GEOLOGY AND SOILS REPORT

**Carriage Meadows South
El Paso County, Colorado**

Re: Response to
Colorado Geological Survey Review Comments
Carriage Meadows South at Lorson Ranch
El Paso County, Colorado

SHEET No.
FIG-22

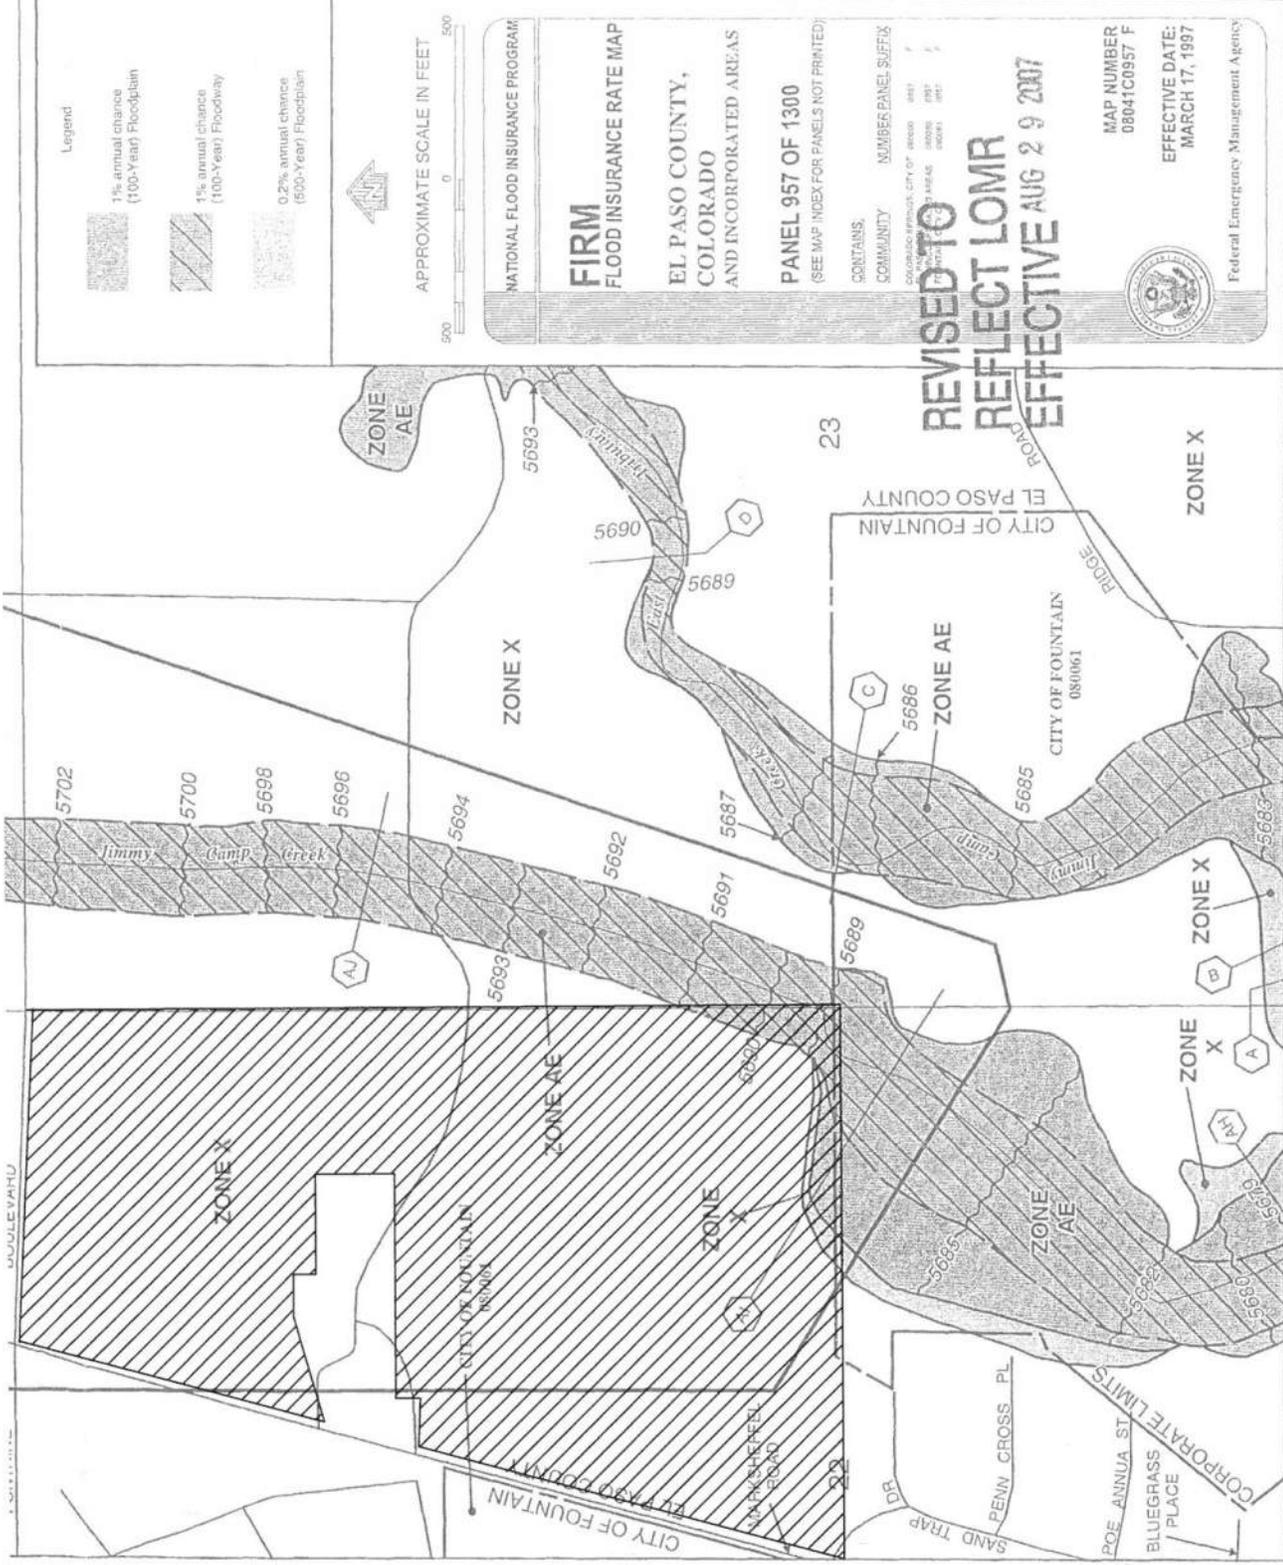
- **Comment:** *"Provide a map (or add to figure 22) of the hazards referenced in the report overlain by the preliminary plan. This will identify specific lots that are not suitable for basements, include artificial fill where structural fill was previously identified, expansive soils (no basements or shallow foundations) or may need underdrains or other mitigation techniques. Identify the floodplain and those lots or roads in said floodplain. Map the potential unstable slopes on this figure to clearly show no lots are proposed in these areas unless mitigation is proposed. Does the southeast portion of the site still have floodplain located on it? There are lots shown here. See Figure 23 revised FEMA map post LOMR). Should a test boring be completed in the area, nearest to the channel that may or may not be in the FEMA floodplain if lots are proposed near the channel and proposed drainage way?"*

The areas of fill identified by Kumar and Associates have been added to Figure 22 of the amended report dated October 7, 2016. The approximate boundary of the 100-year floodplain has also been added to Figure 22 of the amended report dated October 7, 2016. This boundary does not intersect any of the proposed roads, but it does cross the southernmost portion of lots 40 through 45. It is not anticipated that there will be adequate separation between the floodplain and the proposed residences on lots 40 through 42 and 45. Additional care may be required on lots 43 and 44 to ensure that the residence does not encroach within the 100-year floodplain. These areas should be marked as "No Build" zones on the approved plat and/or development plans.
